REMARKS

Disclosure Objections

Drawing Objections

Figure 2
Prior Art

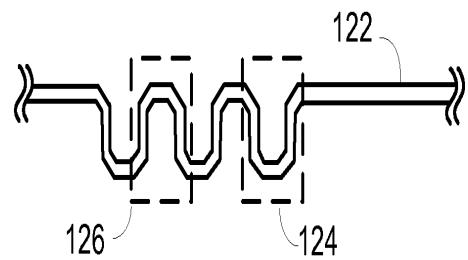
Examiner has objected to the disclosure because reference labels 120, 130, and 140 require a corresponding description in the specification. Figures 2 and 3 have been revised to remove reference numerals 120 and 130. Paragraph [024] of the Specification has been amended to include reference numeral 140.

Figure 4

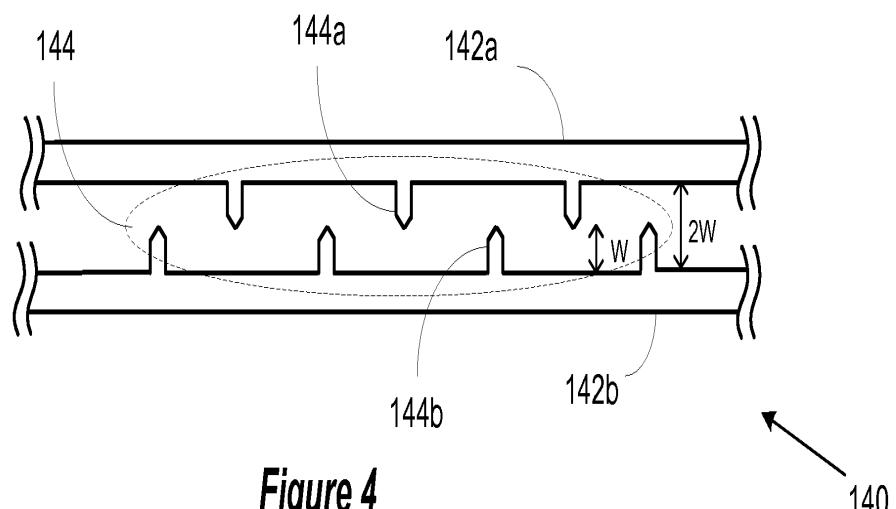
Replacement drawings sheets for Figures 4 and 5 are submitted to overcome Examiner's objections. Figure 4 has been amended to show reference numerals 144 and "W." Figure 5 has been amended to show "3W" for the trace spacing.
